Access Compliance Report

Public Rights-of-Way

(Curb Ramps)

Intersection ID: 14286	Main Street: S_TORRENCE_ST	Cross Street: MAIN_ST	Location: E
ADA ID: 8187962543A2	Ramp Type: PerpDiag	Initial Pass/Fail: Fail	Overall Compliance: No
Severity Score: 8.75			
Codes/Mitigation Info/Possible Solution		Field Measurements/Component Compliance

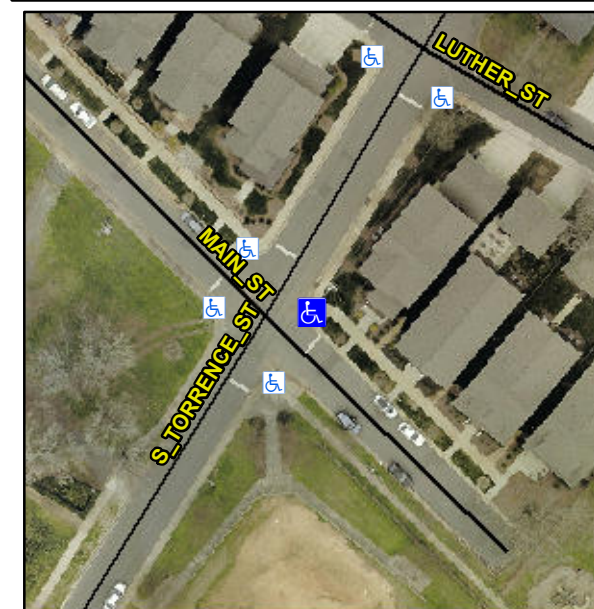
Not Found, R304.5.1

Compliance	Description	Data	Compliance	Description	Data
N/A	Ramp Length (in)	54.0	Yes	Ramp Slope (%)	7.2
No	Ramp Width (in)	36.0	Yes	Ramp XSlope (%)	1.4
N/A	Flare Type LT	N/A	N/A	Flare Type RT	N/A
N/A	Flare Slope LT (%)	N/A	N/A	Flare Slope RT (%)	N/A
N/A	Flare Traversable LT?	N/A	N/A	Flare Traversable RT?	N/A
N/A	Landing Length (in)	N/A	N/A	DWS Provided?	N/A
N/A	Landing Width (in)	N/A	N/A	DWS Contrast?	N/A
N/A	Landing Slope (%)	N/A	N/A	DWS Length (in)	N/A
N/A	Landing X Slope (%)	N/A	N/A	DWS Full Width?	N/A
N/A	Landing Curb? (Y/N)	N/A	N/A	DWS Offset (in)	N/A
N/A	Shared Landing?	N/A			
N/A	Gutter Ponding?	Yes	N/A	Gutter Slope (%)	N/A
N/A	Gutter Lip Ht (in)	N/A	N/A	Gutter X Slope (%)	N/A
N/A	Painted X Walk1?	No	N/A	Painted X Walk2?	No
	X Walk 1 Direction	To NW		X Walk 2 Direction	To SW
N/A	X Walk 1 Width (in)	N/A	N/A	X Walk 2 Width (in)	N/A
	X Walk 1 Slope (%)	1.2		X Walk 2 Slope (%)	0.6
	X Walk 1 X Slope (%)	1.5		X Walk 2 X Slope (%)	1.5

Remove & Replace Curb Ramp With Two New Directional Ramps or Equivalent.
